Redlined Site Plan

Redlined Landscape Plan

PROJECT: LEMOORE APARTMENT COMPLEX

Red lined Elevations

BUILDING TYPE - 1

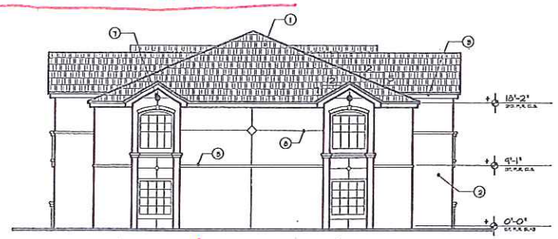
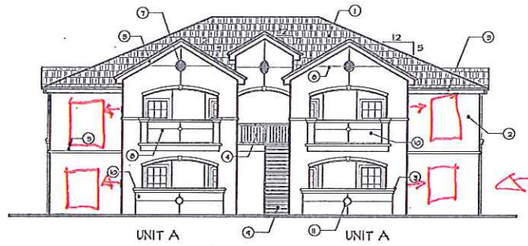
Floor Plans show wider patio, and windows

TYPICAL STREET ELEVATION

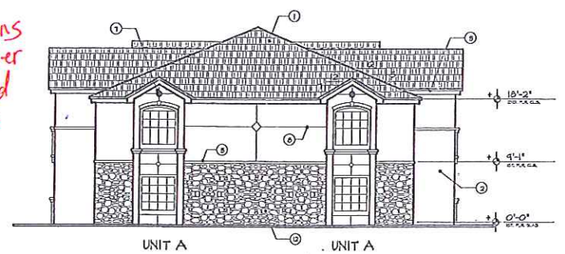
May have fire code issue on building with less than 20' building seperation. #13

BUILDING TYPE - 2

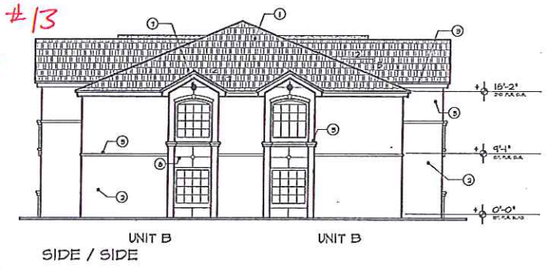
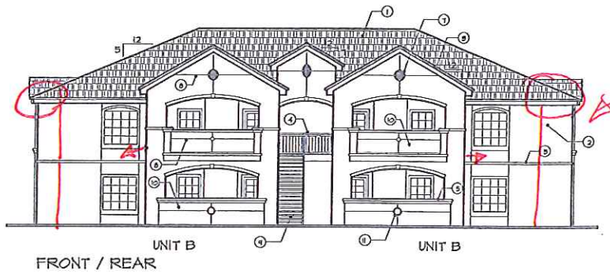
Floor plan shows wider patio and a change in plane that will affect the roof line, more similar to what is shown in bldg. C below.

BUILDING TYPE - 4

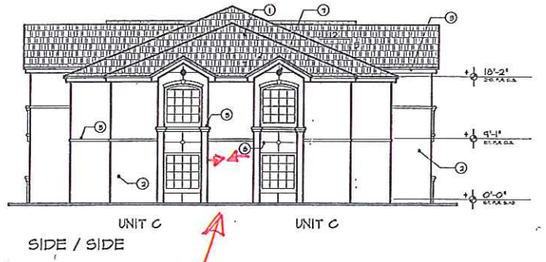
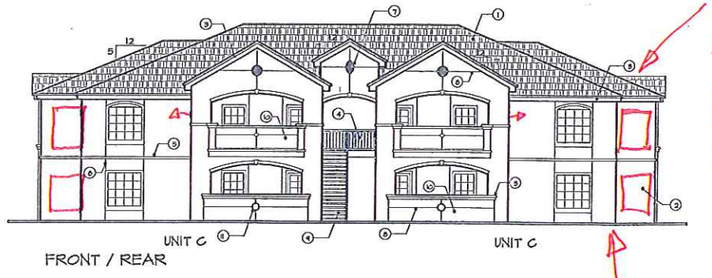
Floor plan shows wider patios and additional bedroom windows

Floor plan shows these window sets closer to one another.

Building plane does not change on floor plan

FLOOR PLAN UNIT A - 650 SQ. FT.
1 BR-1 B

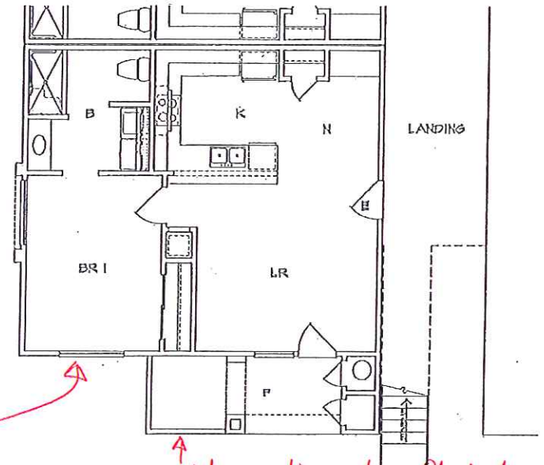
Missing on elevation

wider patio not reflected in elevation

FLOOR PLAN UNIT B - 923 SQ. FT.
2 BR-2 B

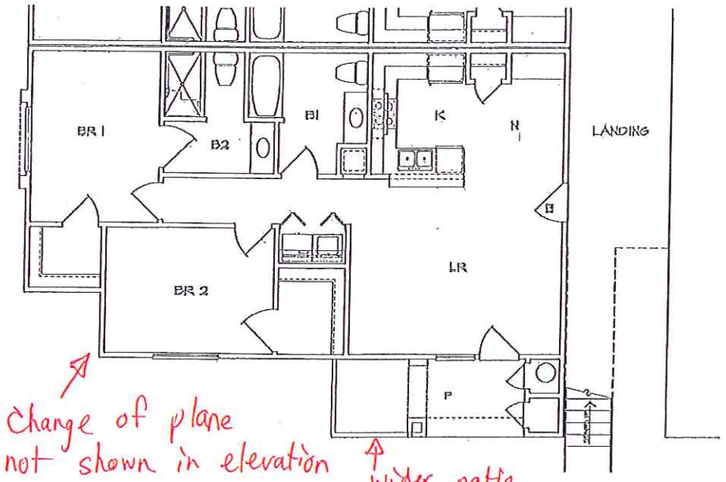
Change of plane not shown in elevation

wider patio not reflected in elevation

FLOOR PLAN UNIT C - 1100 SQ. FT.
3 BR-2 B

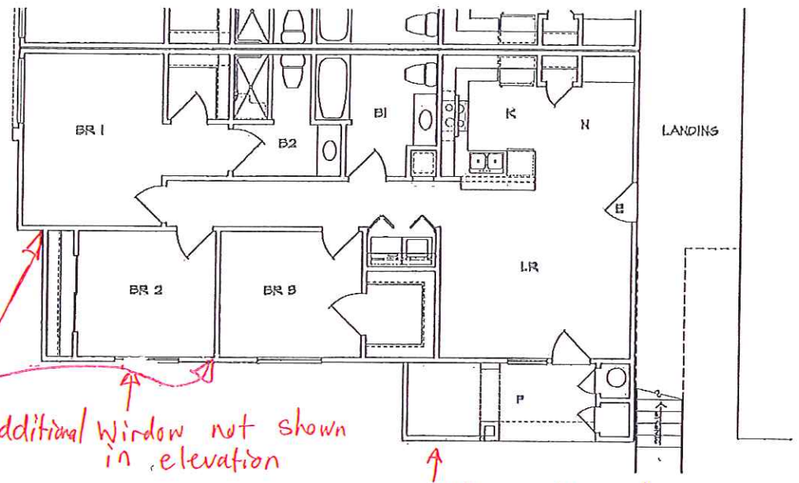
Additional Window not shown in elevation

Wider patio not reflected in elevation

Elevation shows change in building here instead of outside area
